ADA Curb Ramp New Construction Inspection Form (Parallel)

NW 309th	24952.54				Turel	
North-South Road Name	Project No.	Sheet No.	Intersection No.	East-West Road Name	See https://www.oregon.gov/odot/Engineering/Documents_RoadwayEng/ADA_ExhibitA.pdf for more corner styles. Use Washington County corner numbering system.	
Calibration Date 10/25/2024 (mm/dd/yy)

PARALLEL RAMP (PL)

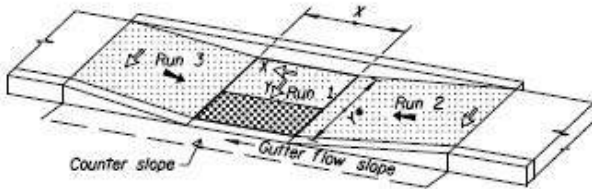
RAMP RUN 1		Pass	Fail
Running Slope 1	<input type="text" value="5.2"/> ≤ 2.0% <input type="checkbox"/> > 2.0% <input checked="" type="checkbox"/>		
Cross Slope 1	<input type="text" value="5.2"/> ≤ 2.0% <input type="checkbox"/> > 2.0% <input checked="" type="checkbox"/>		
Detectable Warning	<input type="text" value="N"/> Y <input type="checkbox"/> N <input checked="" type="checkbox"/>		
Lip Height	<input type="text" value="0.5"/> ≤ 1/4" <input type="checkbox"/> > 1/4" <input checked="" type="checkbox"/>		
Gutter Flow Slope	<input type="text" value="5.7"/> ≤ * <input type="checkbox"/> > * <input checked="" type="checkbox"/>		
Curb Running Slope (avg)	<input type="checkbox"/> <input type="text" value="6.44"/> ≤ 8.3% <input checked="" type="checkbox"/> > 8.3% <input type="checkbox"/>		
Counter Slope (+/-)*2	<input type="text" value="7.4"/> ≤ 5.0% <input type="checkbox"/> > 5.0% <input checked="" type="checkbox"/>

Det. warning full width of ramp	<input type="text" value="N"/> Y <input type="checkbox"/> N <input checked="" type="checkbox"/>

RAMP RUN 3		Pass	Fail
Running Slope 3	<input type="text" value="11.3"/> ≤ 8.3% <input type="checkbox"/> > 8.3% <input checked="" type="checkbox"/>		
Length 3	<input type="text" value="8"/>		
Cross Slope 3	<input type="text" value=""/> ≤ 2.0% <input type="checkbox"/> > 2.0% <input checked="" type="checkbox"/>

TURN SPACE		Pass	Fail
Width X	<input type="text" value="4.1"/> ≥ 4.0' <input type="checkbox"/> < 4.0' <input checked="" type="checkbox"/>		
Length Y	<input type="text" value="4.95"/> ≥ 4.0'*1 <input type="checkbox"/> < 4.0'*1 <input checked="" type="checkbox"/>		
Back of Ramp Obstruction (Y/N)	<input type="text" value="Y"/> ≥ 5.0'*1 <input type="checkbox"/> < 5.0'*1 <input checked="" type="checkbox"/>		
Slope X (Cross Slope 1)	<input type="text" value="5.2"/> ≤ 2.0% <input type="checkbox"/> > 2.0% <input checked="" type="checkbox"/>		
Slope Y (Running Slope 1)	<input type="text" value=""/> ≤ 2.0% <input type="checkbox"/> > 2.0% <input checked="" type="checkbox"/>

No Td. CRK curb and gutter.
